## MEMORANDUM

**Subject: Hill Street Terraces – Updated Transportation Analysis**

Hill Street Terraces

# Figure 1 - Site Plan

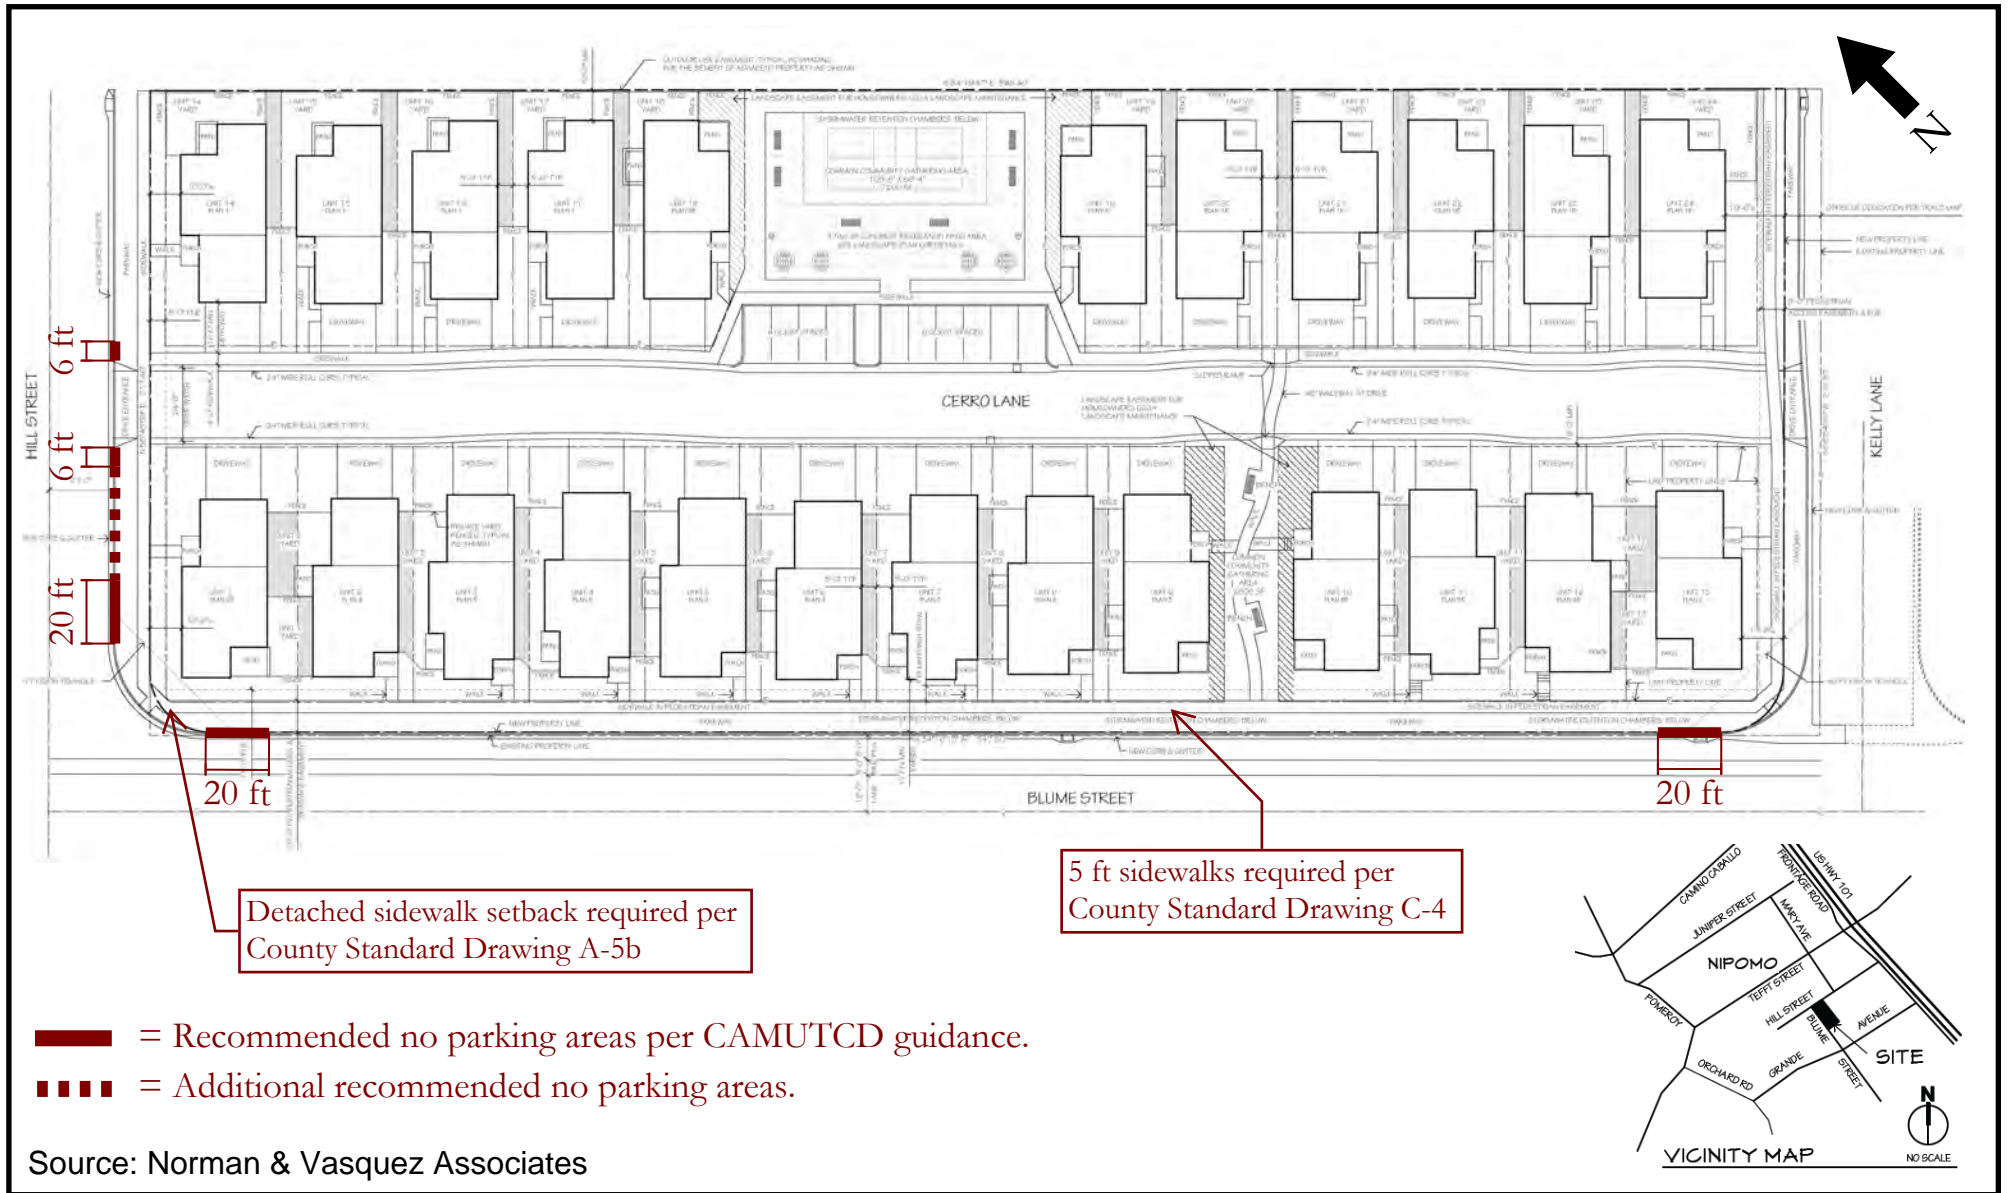
The project will construct frontage improvements on Hill Street and Blume Street adjacent to the project. Consistent with other portions of Blume Street, Class II bike lanes are recommended as proposed. In general, the proposed improvements comply with County Standards; however, a detached sidewalk setback is required per County Standard Drawing A-5b and five-foot detached sidewalks are required per County Standard Drawing C-4. We recommend that no parking areas be installed on Blume Street and Hill Street for sight distance consistent with California Manual on Uniform Traffic Control Devices (CAMUTCD) guidance. The frontage improvement and no parking recommendations are also shown on **Figure 1**.

CCTC reviewed the site plan shown on **Figure 1**. The project will construct Cerro Lane (a private road) from Hill Street to Kelly Lane, as well as frontage improvements on Hill Street, Blume Street, and Kelly Lane.

Per CAMUTCD guidance, “At all intersections, one stall length on each side measured from the crosswalk or end of curb return should have parking prohibited. A clearance of 6 feet measured from the curb return should be provided at alleys and driveways.” We recommend red curb and/or no parking signs be installed on Blume Street and Hill Street consistent with CAMUTCD guidance. With the no parking recommendations, less than two parking spaces (approximately 36 feet) would be available on Hill Street between Blume Street and the Hill Street driveway. To maximize sight distance for drivers exiting the driveway we also recommend parking be removed in this location. The recommended no parking areas are shown on **Figure 1**.

The site plan currently shows four-foot detached sidewalks; however, five-foot detached sidewalks are required per County Standard Drawing C-4. In addition, all intersection approaches shall comply with County Standard A-5a and A-5b and the detached sidewalk setback in A-5b is not currently shown.

County Standard Drawing A-2c is also recommended on Hill Street and County Standard Drawing A-2b is recommended on Kelly Lane. The improvements are generally consistent with a 21-foot cross-section proposed on Hill Street. The frontage improvement recommendations are shown on **Figure 1**.
